Title			
BIRDS5 FAB ADC & Connectors			
Size	Document Number		Rev
B	B5-0001-2-4		0.4
Date:	Tuesday, October 20, 2020	Sheet	1 of 3

Title			
RBF switch			
Size A	Document Number		Rev 0.4
Date:	Tuesday, October 20, 2020	Sheet	3 of 3

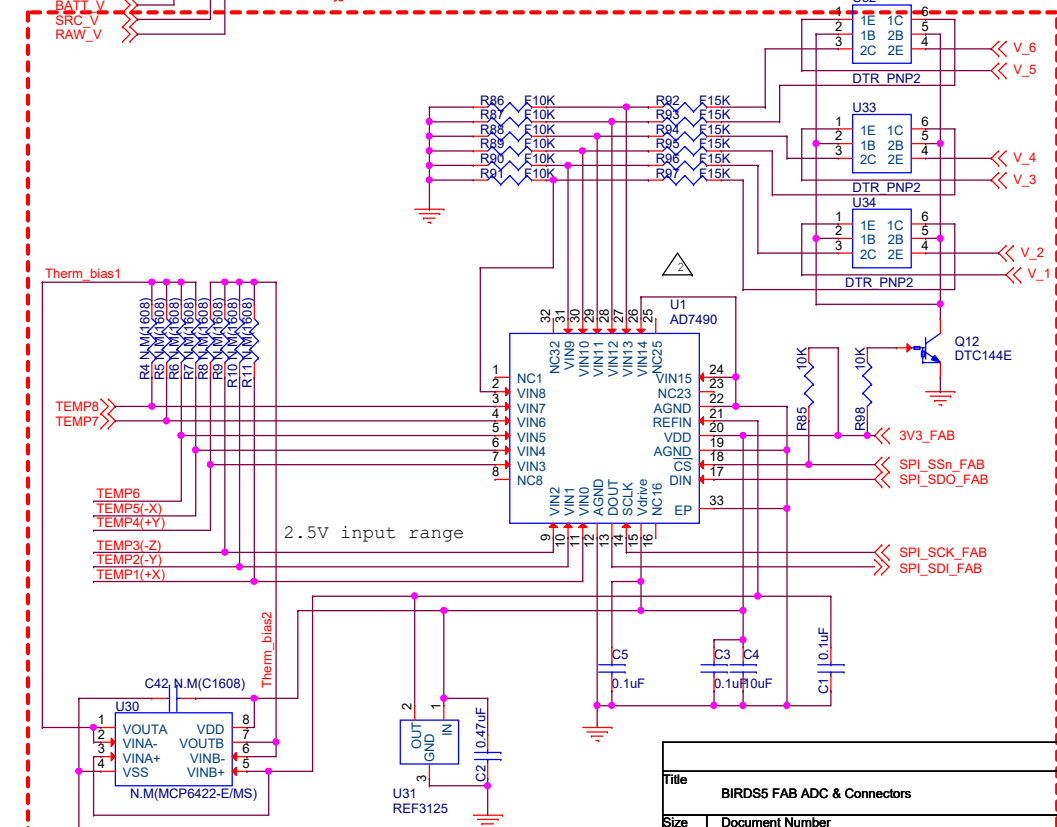
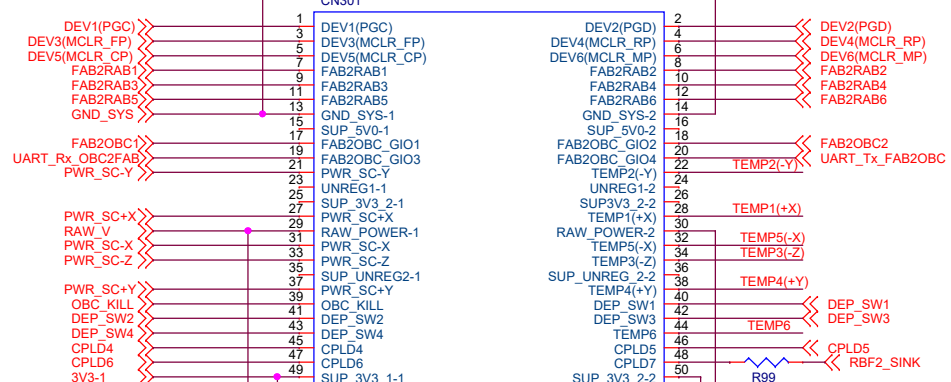
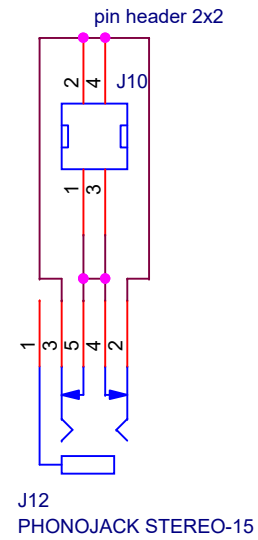
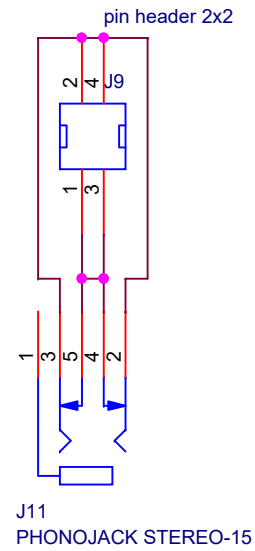
V0.30 2020/10/14  
 Connect RBF2 SINK to the pin48 of CN301  
 Insert R99 (1kOhm) resistor  
 Change pull-down signal for MOSFET (U25, U26) from  
 GND SYS to RBF2 SINK  
 D1 (DPS2100) -> NRVB120V5FT1G  
 D15 (NRVB120V5FT1G) add  
 Q11 (SSM6K411TU) -> SSM6K514NU  
 C43 (3300pF) add
